N3 Virginia Bypass
Stage F Part 2 Road Safety Audit

Barry Transportation

Stage F Part 2 Road Safety Audit

Figure 2.2 – Low Point in Vertical Profile

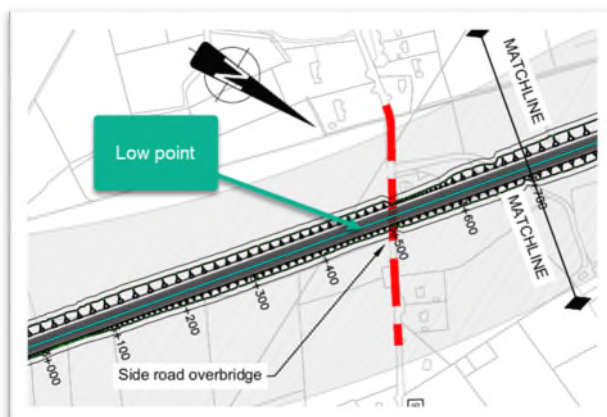
2.2 Problem: Managing Run-Off at Low Point

Location: Mainline Chainage 3+460m

The low point at Chainage 3.460m coincides with a number of house dwellings. This could lead to surface water run-off gathering around the houses during significant rainfall events.

Appropriate drainage measures should be provided to mitigate the risk described.

2.1	Y	Y	Appropriate separation will be investigated in further detail during Phase 3 of planning and design process.	Noted
2.2	Y	Y	Appropriate drainage measure will be investigated in further detail during Phase 3 of planning and design process.	Noted

Figure 2.3 – SSD at Side Road / Underbridge

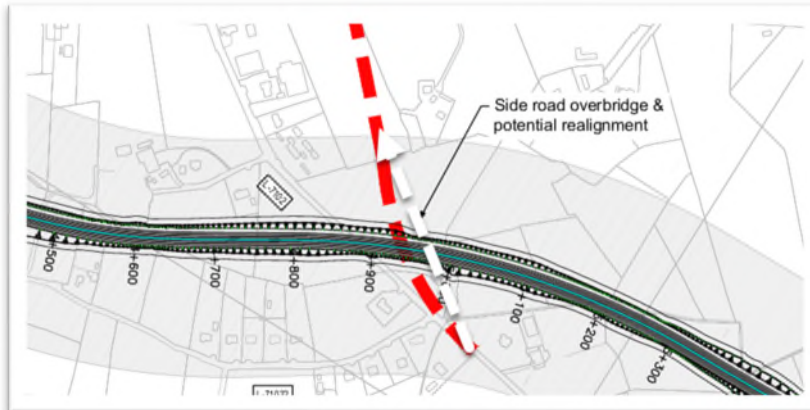
2.3 Problem: Forward Stopping Sight Distance (SSD)

Location: Side Road L-7103 Re-Alignment Mainline Chainage 4+950m

The overbridge could limit forward stopping sight distance on the side road, leading to rear end shunts or loss of control type collisions.

Appropriate forward stopping sight distance should be provided at the location described.

2.3	Y	Y	Appropriate visibility requirements will be investigated in further detail during Phase 3 of planning and design process.	Noted
2.4	Y	Y	Appropriate visibility requirements will be investigated in further detail during Phase 3 of planning and design process.	Noted

Figure 2.4 – Embankment on Approach to Junction

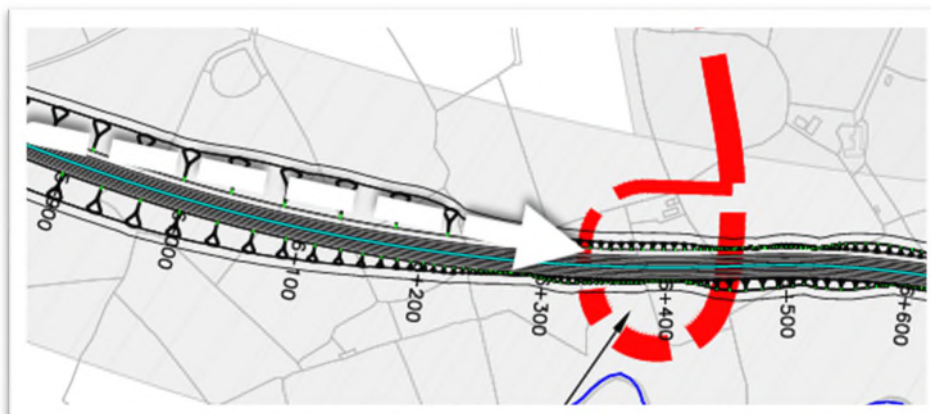
2.4 Problem: Cutting Obscuring Compact Junction

Location: Alignment Mainline Chainage 4+950m

The cutting earthworks could obscure the presence of the junction for northbound drivers. This could lead to late braking and rear end shunt type collisions.

The earthworks should be designed to ensure that the junction is 'self-reading' on approach.

Figure 2.6 – Need for 'Self Reading Junction Layout' for New Roundabout

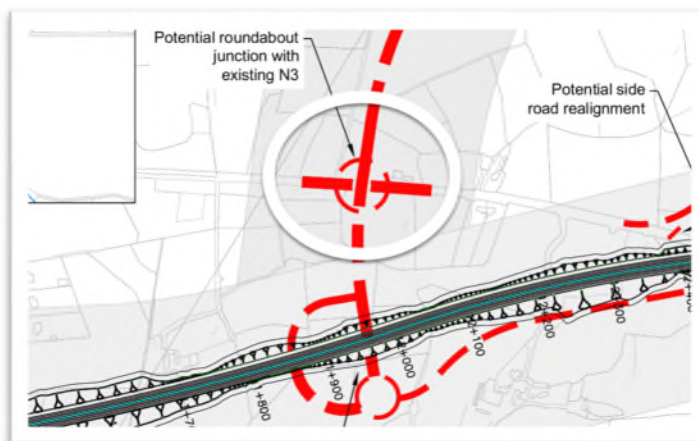
2.6 Problem: New Roundabout on Existing Undulating Alignment

Location: Existing N3 at South of Mainline Chainage 11+950m

The combination of high operating speeds and undulating vertical alignment could increase the risk of collisions at the new roundabout.

The approach alignment of the existing N3 should be designed to maximise the conspicuousness of the roundabout.

2.5	Y	Y	Appropriate visibility requirements will be investigated in further detail during Phase 3 of planning and design process.	Noted
2.6	Y	Y	Appropriate visibility requirements will be investigated in further detail during Phase 3 of planning and design process.	Noted

Figure 2.7 – Access Road Beside Mainline

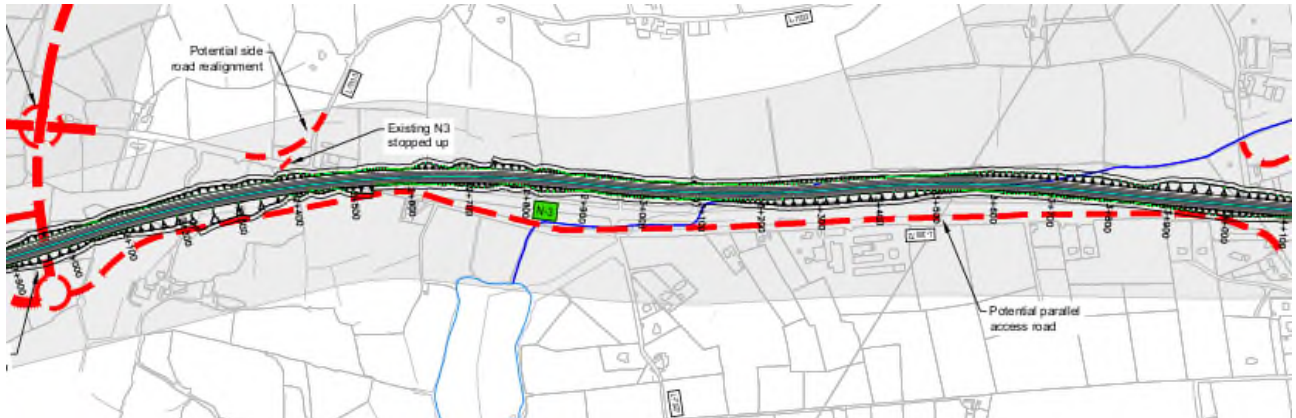
2.7 Problem: Inter-Visibility Between Mainline and Access Road

Location: Mainline Chainage 12+100m to 12+900m

Where the access road will run parallel to the mainline, there is a risk of headlight distraction and an errant vehicle crossing from one road to the other.

Appropriate containment measures and screening should be provided at the location described.

2.7	Y	Y	Appropriate intervisibility screening and containment requirements will be investigated in further detail during Phase 3 of planning and design process.	Noted

Figure 2.8 – Example Properties at Southern Tie In Where Access Provision will be Required

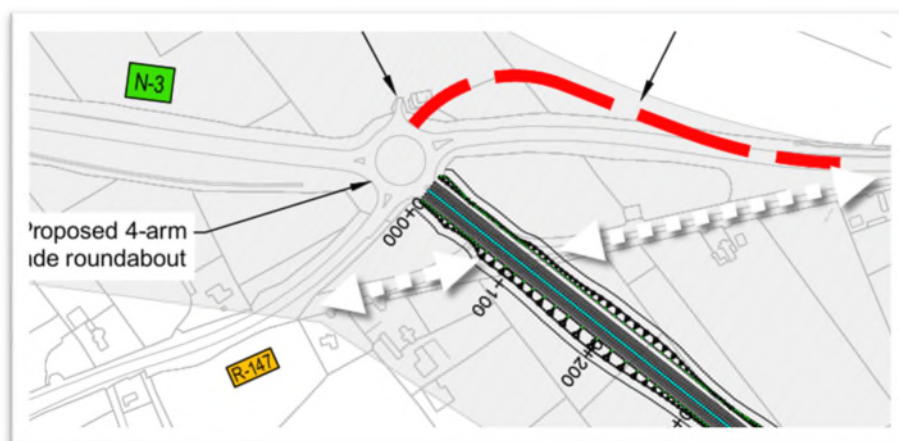
2.8 Problem: Maintaining Access to Existing Properties

Location: Route Wide

Failing to provide suitable access to existing private properties which are directly impacted upon by the route, could lead to motorists undertaking prohibited (or unsafe) manoeuvres which might increase the risk of collisions occurring.

Appropriate access should be provided to existing properties which are directly impacted upon by the route.

2.8	Y	Y	Appropriate property and farmland access will be investigated in further detail during Phase 3 of planning and design process.	Noted
2.9	Y	Y	Appropriate property and farmland access will be investigated in further detail during Phase 3 of planning and design process.	Noted
